Groundwater Application Review Summary Form

Application # ~~G-18850~~ G-18850

PUBLIC INTEREST REVIEW FOR GROUNDWATER APPLICATIONS

TO: Water Rights Section Date 09/17/2019
 FROM: Groundwater Section M Thoma
 Reviewer's Name
 SUBJECT: Application G- 18850 Supersedes review of
 Date of Review(s)

Stream-Depletion Model Results

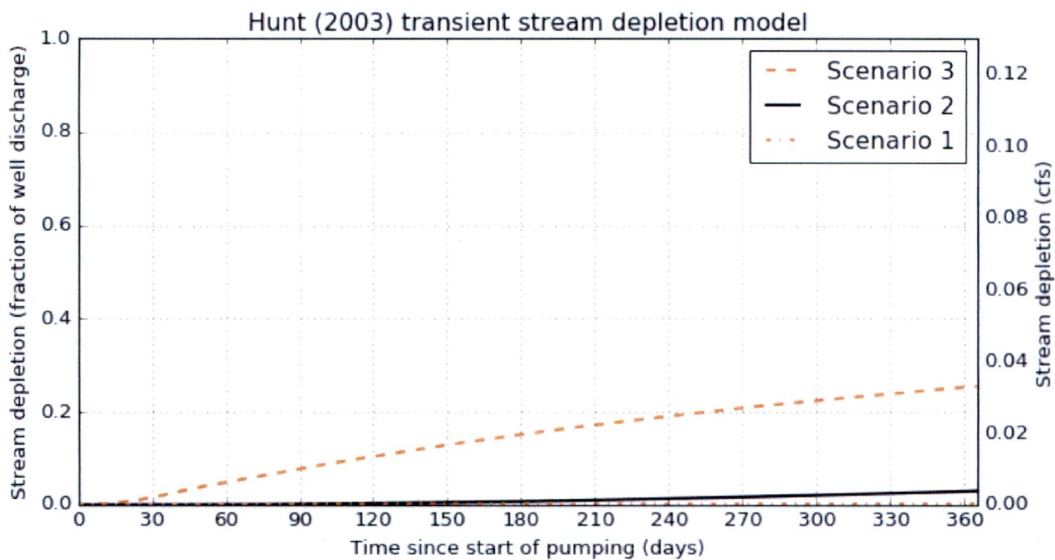
Comments: stream-depletion was estimated using the Hunt-2003 model with parameter values assigned from a range that represents likely values for the given aquifers.

C6. **SW / GW Remarks and Conditions:** The applicant's proposed POAs would be producing from an aquifer that has been found to be hydraulically connected to surface water – specifically Gettings Creek and the Coast Fk Willamette River – at a distance of less than 1 mile. POA #1 is within ¼ mile of Gettings Creek and found to be hydraulically-connected so, per OAR 690-009 rules, POA #1 is assumed to have the Potential for Substantial Interference. POA #2 is also found to be hydraulically-connected to Gettings Creek but is at a distance of greater than ¼ mile. Both POAs are also found to be hydraulically-connected to the Coast Fk Willamette River at distances greater than ¼ mile. For both POAs, the proposed maximum rate of appropriation is less than 1% of the pertinent adopted perennial streamflow and also less than 1% of the adopted instream water rights for either surface water source and stream-depletion is estimated to be less than 25% at 30 days.

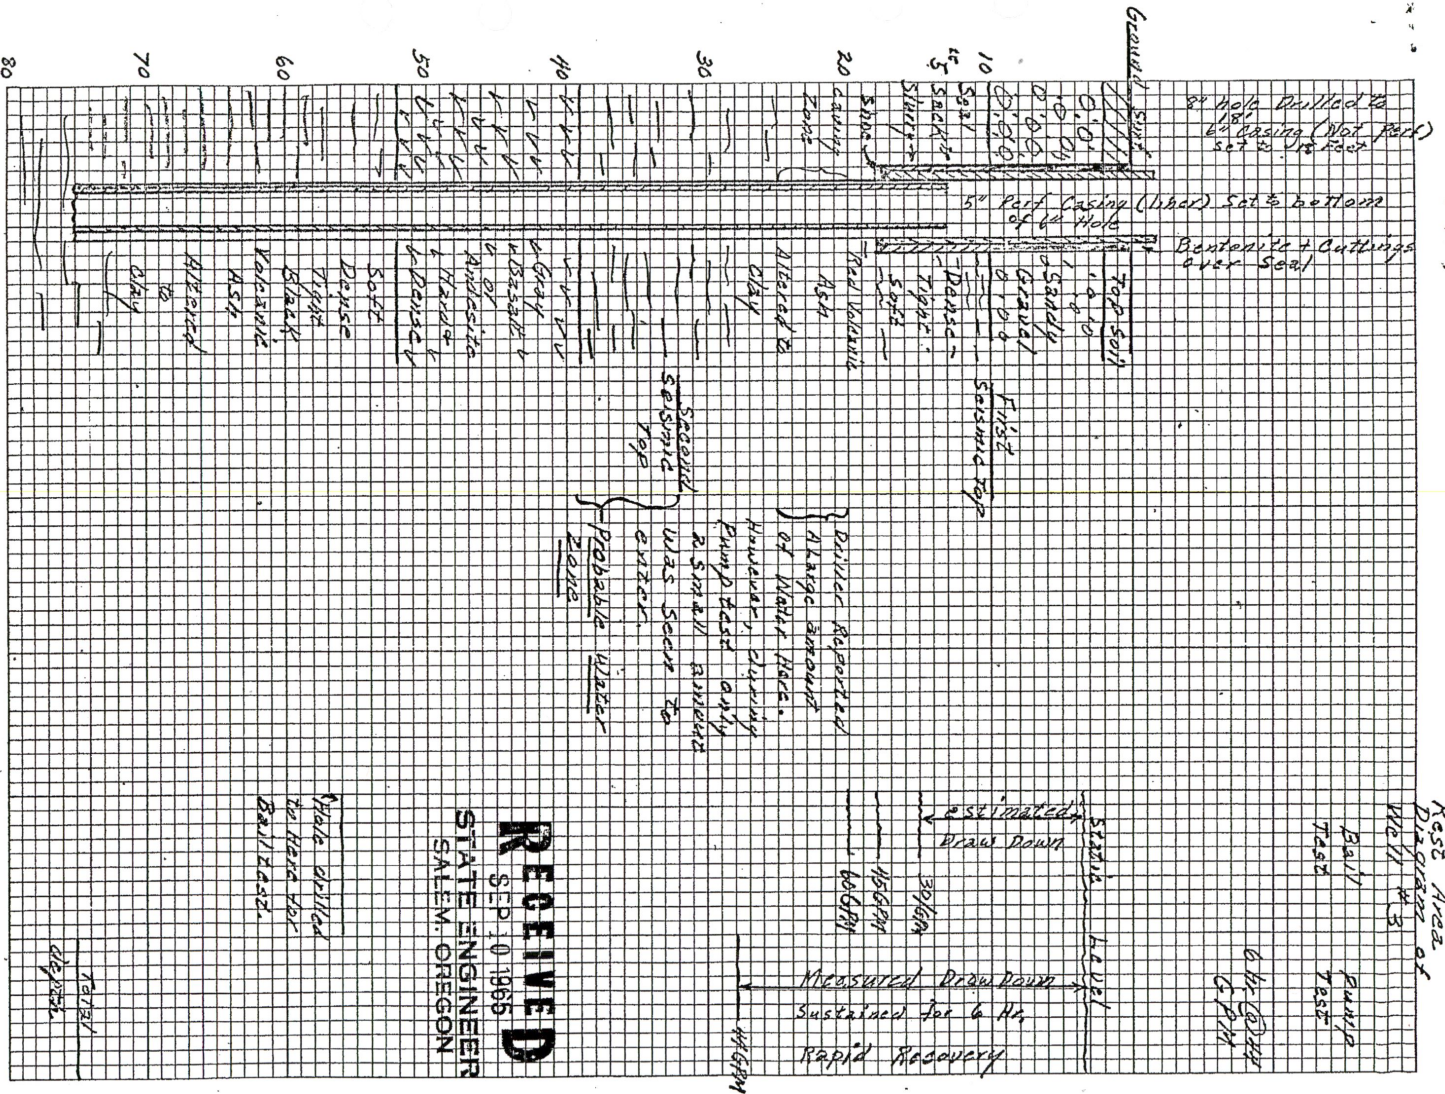
It was recommended that the method of completion be modified from specifications to that illustrated on the accompanying sheet of drawings because of the nature of the red volcanic ash. If the 6" casing were driven into the basalt layer, there would be a great risk of sealing off the water with clay and not being able to recover it upon perforation of the casing. Other reasons for this type of completion in this situation are:

- 1) The liner can be removed and the perforations cleaned.
- 2) With the liner out, the well can be cleaned, deepened, or reamed.
- 3) This all can be done without disturbing the seal which prevents the surface water from entering the well.
- 4) This method was discussed with Jack Sceva and William Bartholomew of the State Engineer's office. They express their approval.
